RE: ENGINEER'S CERTIFICATION FOR WALGREENS - INDIAN SCHOOL AND
TRAMWAY, (J-23/ D010), ENGINEER'S STAMP DATED 06/12/00,
CERTIFICATION DATED 7/14/2000.

Based upon the information provided in your submittal dated July 14, 2000, the Engineering Certification for Certificate of Occupancy for the project referred to above is approved.

WALGREENS - INDIAN SCHOOL GRADING & DRAINAGE PLAN

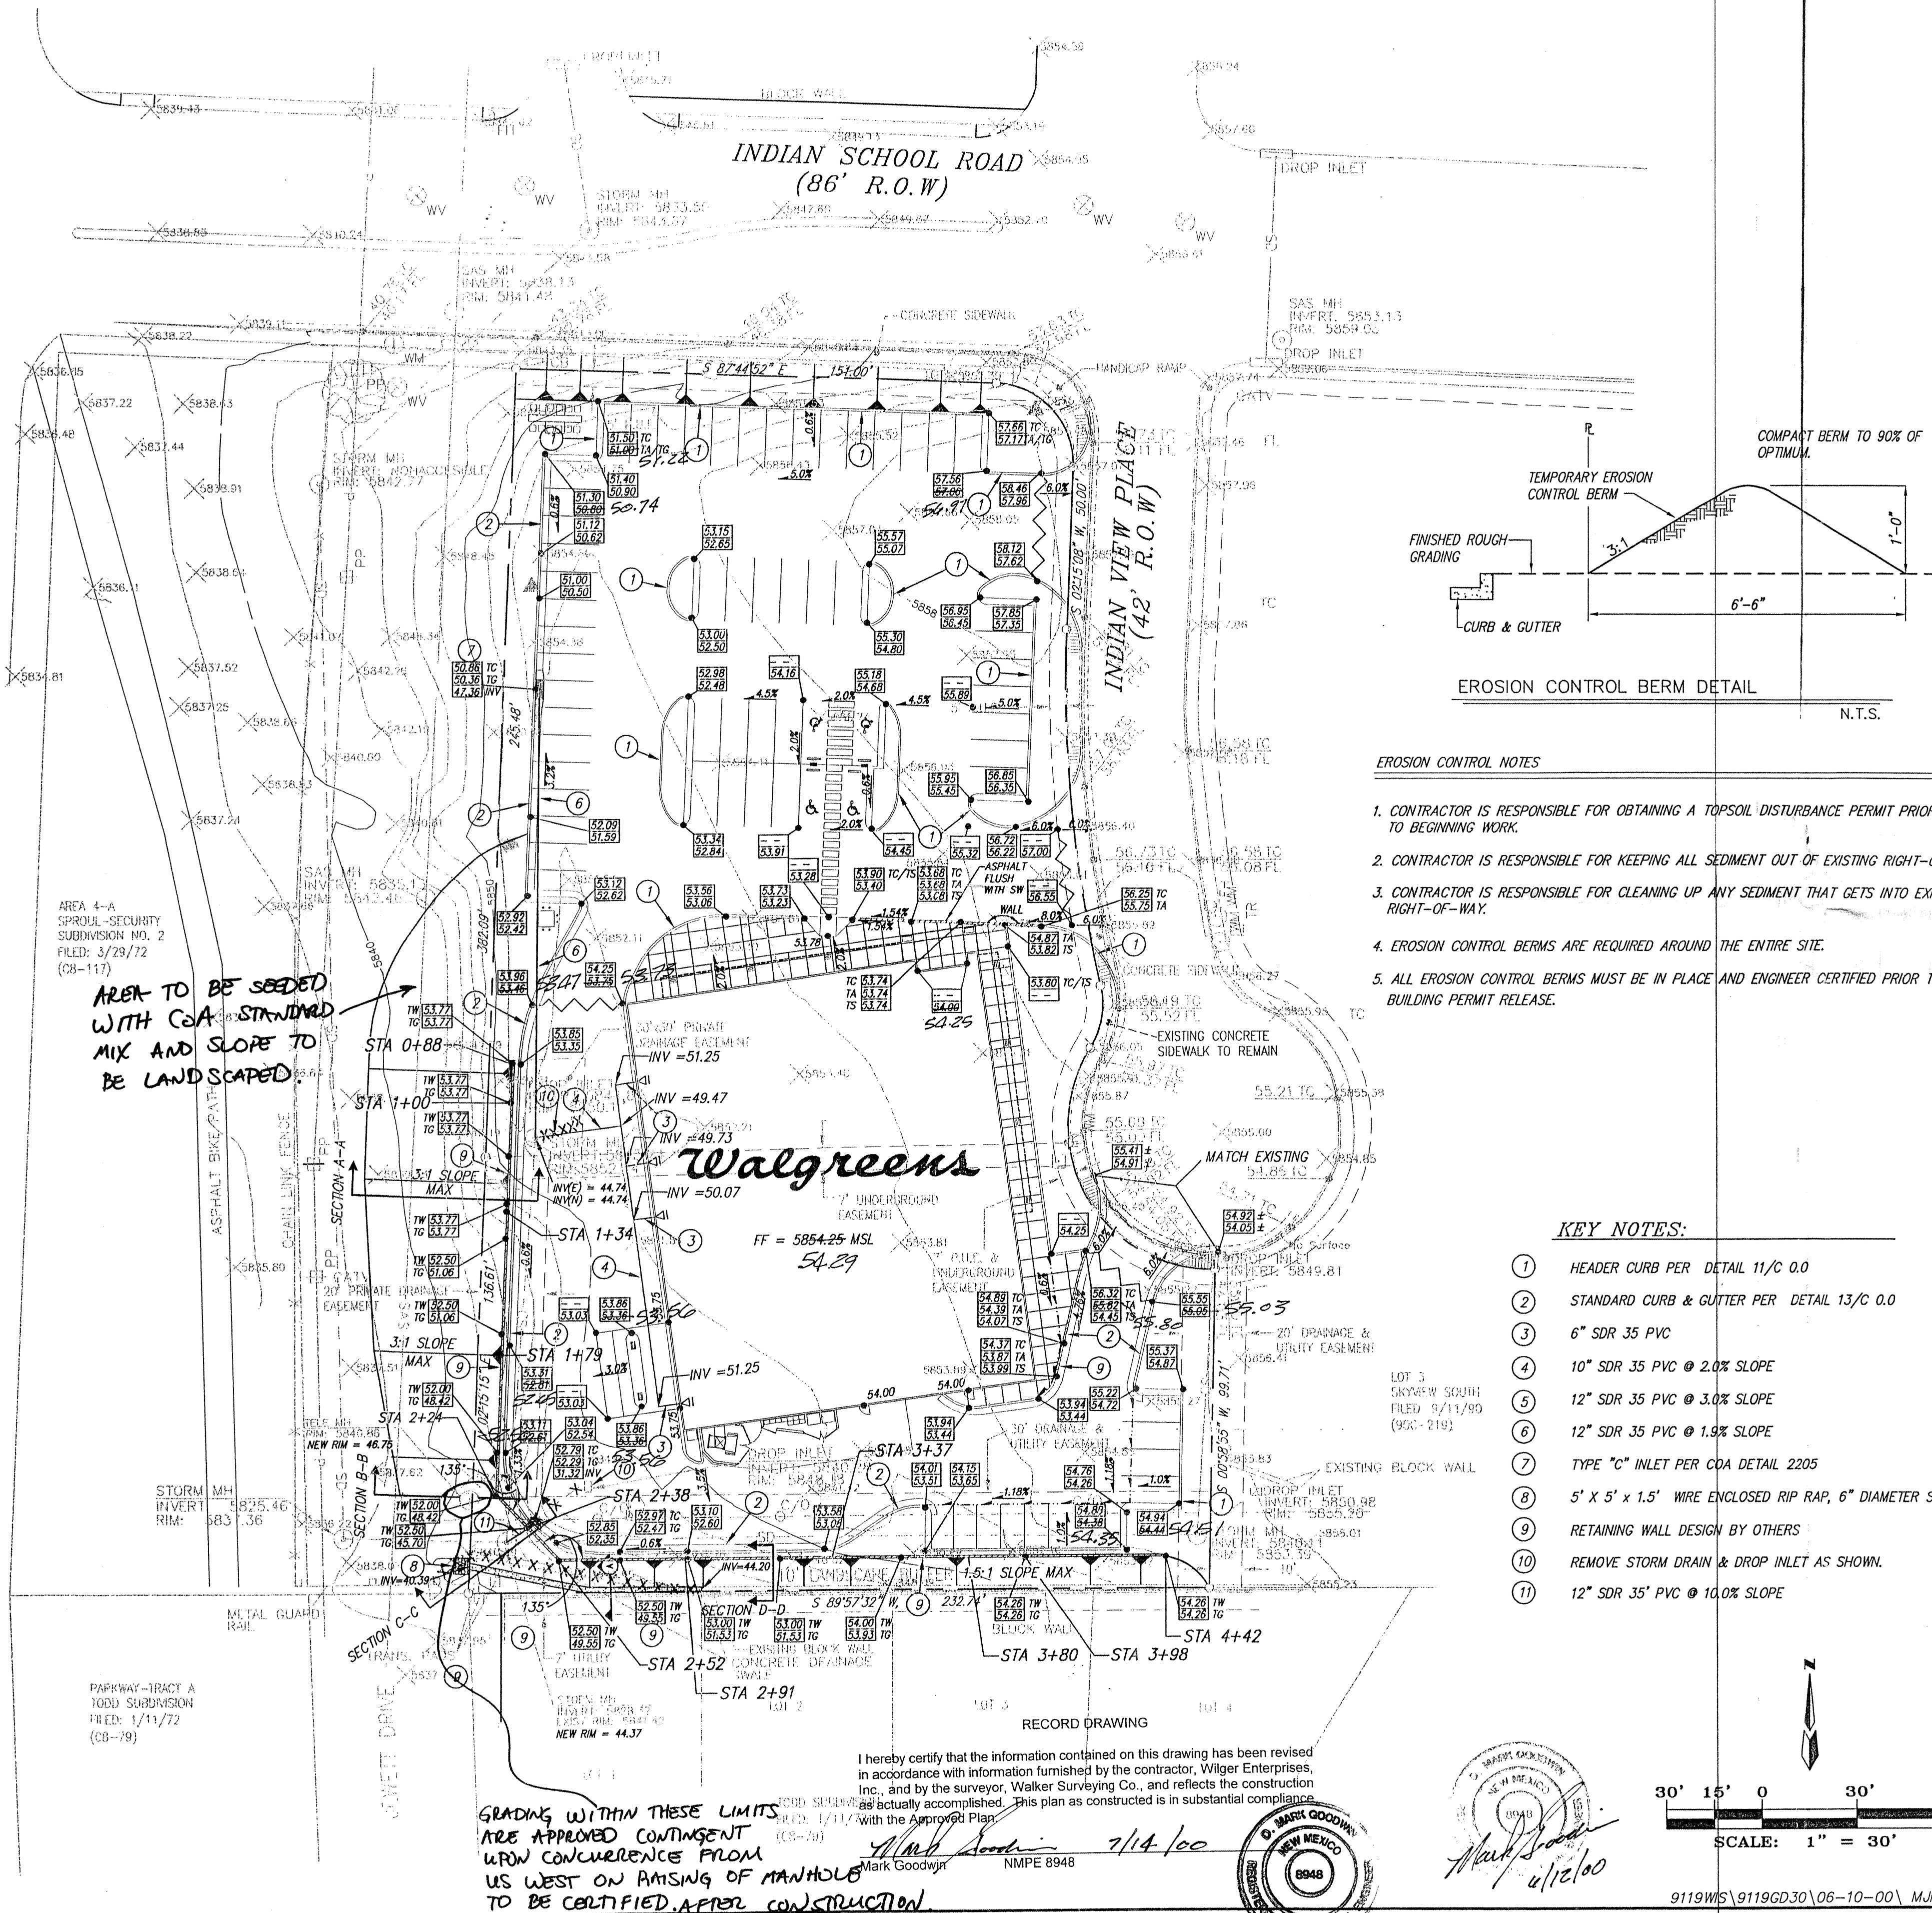
GRADING WITHIN THESE LIMITS
ARE APPROVED CONTINGENT
UPON CONCURRENCE FROM
US WEST ON RAISING OF MANHOLE
TO BE CERTIFIED AFTER CONSTRUCTION
